RESPONSE TO SUBMISSIONS TO  
PROPOSED GLASS BENEFICIATION PLANT  
ENVIRONMENTAL IMPACT STATEMENT  
126 ANDREWS ROAD, PENRITH

*Prepared for:* GLASS RECOVERY SERVICES  
DEPARTMENT OF PLANNING & INFRASTRUCTURE

*Report No:* 137010\_Rep\_Rev1  
August 2013  
(Released: 30 August 2013)

Figure 1: Predicted PM<sub>10</sub> Impacts from Operation (Stage 2) - 24-Hour Averaging Time with Background Concentration (Cumulative Impacts)

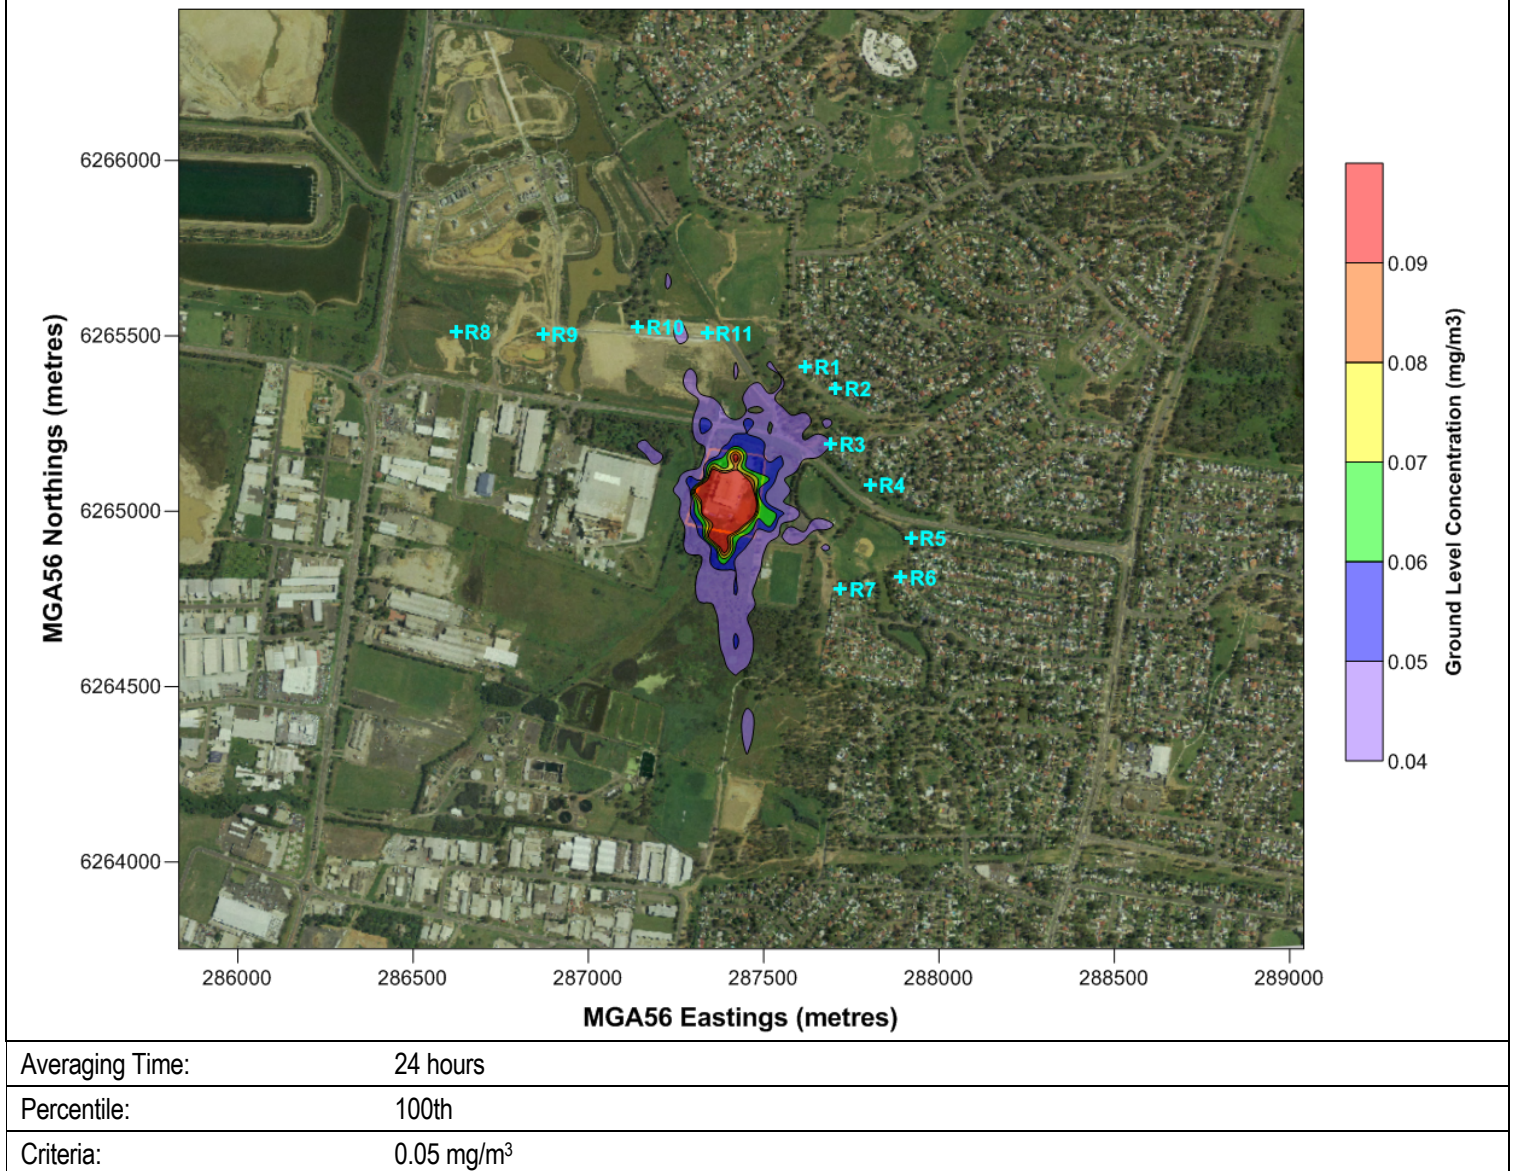
*It is noted that the development does not comply with the relevant criteria for PM10 unless water sprays are utilised. Importantly, even when the use of these sprays has been modelled, there still appears to be a significant impact south of the site, as shown in Figure 5-27. Although there are no identified receivers in this area (and no receivers assessed), it is not clear how far this plume extends to the south (the figure does not show where the area of impact ends), and there are residents and recreational facilities located in this direction. It needs to be considered whether such a large area of affectation is appropriate.*

Given the request from Penrith City Council, the expanded ground level concentration isopleth diagram for the PM<sub>10</sub> 24-hour impacts have been provided as Figure 1 of this addendum. Please note that this result includes the depletion effects due to scavenging and deposition of particulates, as it migrates off-site.

The PM<sub>10</sub> 24-hour impacts of the Stage 2 development as shown in the Figure 1 do not reach or extend to areas where residential premises are located. The 0.05 mg/m<sup>3</sup> criteria line is depicted by the contour that separates the purple line from the blue line in the figure presented below. It is however acknowledged that the 0.05 mg/m<sup>3</sup> contour line is seen to be present at a reasonable distance away south of the site.

**Figure 1: Drainage Concept**

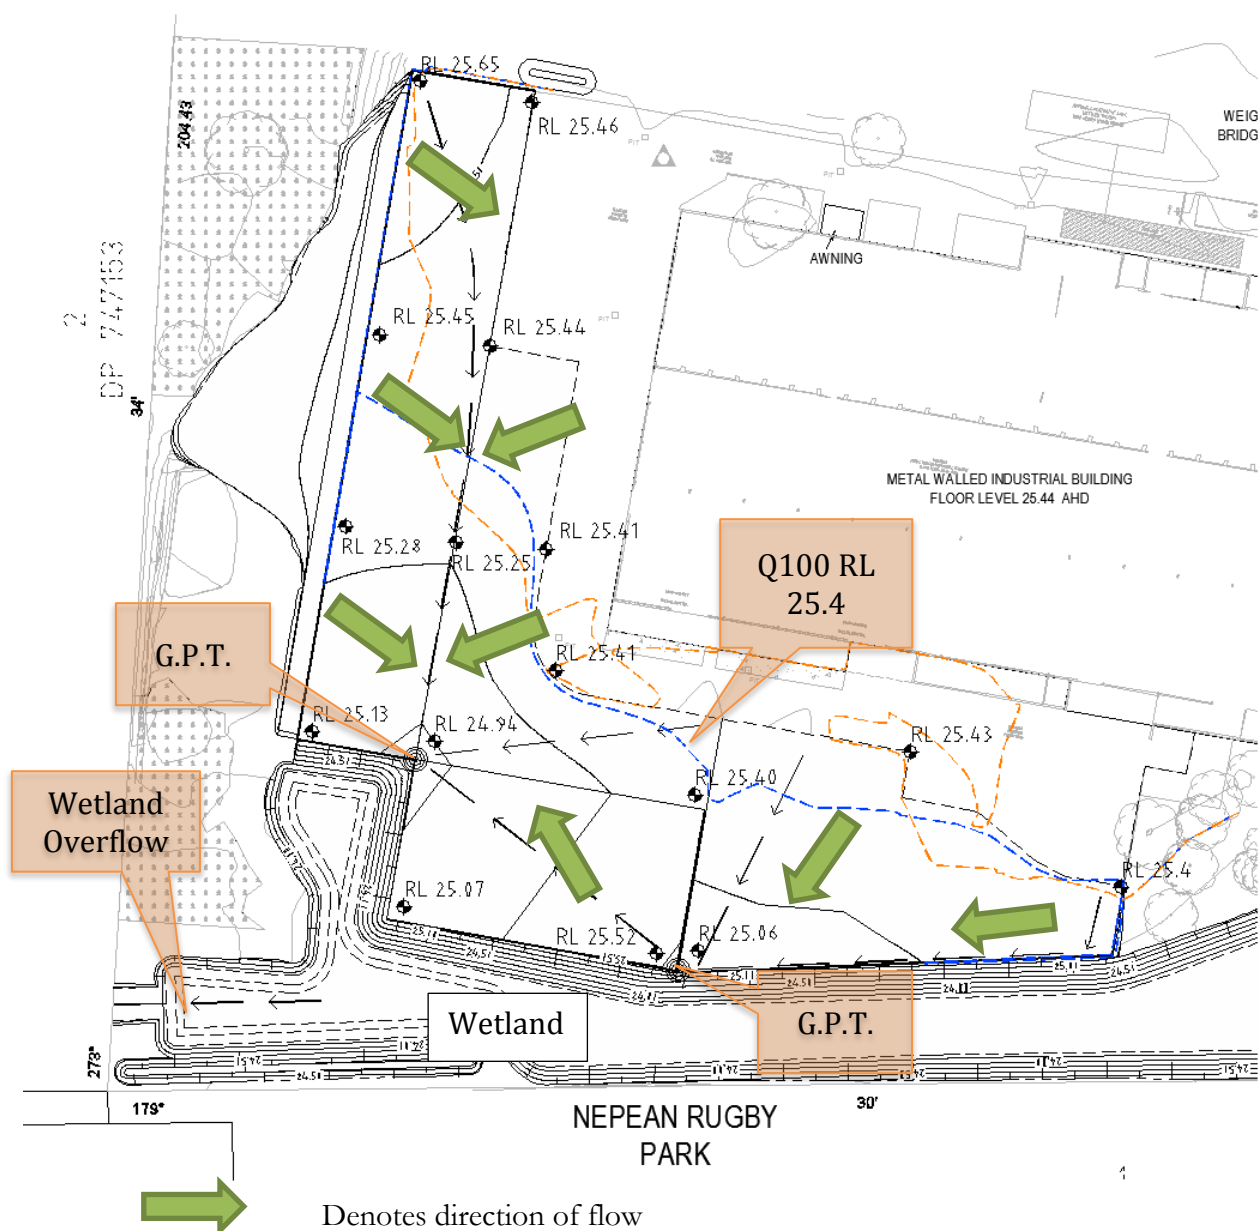
- Clarify whether the bunkers will be constructed so that these will not be inundated or discharge waste and/or leachate during a 1 in 20 year ARI flood event and during the 1 in 100 year ARI flood event.
  - The 1 in 20 year ARI flood level was not provided to Brown Consulting from Penrith City Council therefore an assessment on inundation cannot be made without further information. In the 1 in 100 year ARI flood event the bunkers will be inundated however the site is to drain in such a manner that flows are directed to G.P.T's as further explained below.
- Clarify the drainage of this area is to include;
  - Whether the bunker will be designed to drain to the wetlands.
    - The bunkers are designed to drain to the wetlands but not before draining to the proposed G.P.T's as shown in **Figure 1** below.

- Whether the GPT's constructed at the two low points will collect runoff from the bunkers and will be able to remove entrained glass cullet.
    - The GPT's proposed are CDS type units or equivalent and will be capable to capture any glass cullet carried by runoff before outflowing into the proposed wetland.
- Clarify the design parameters of the constructed wetland, to include polishing of runoff from the bunkers.
  - The wetland was sized in *MUSIC*. The wetland and GPT's were sized in order to meet the pollution reduction targets of 85% reduction of Total Suspended Solid, 45% reduction of Total Phosphorus, and 45% of Total Nitrogen generated from the area of new works on site. Modelled rainfall data used in the *MUSIC* model was modified to suit local Penrith conditions and the catchment pollutant concentration parameters based on those specified in *Draft NSW MUSIC*
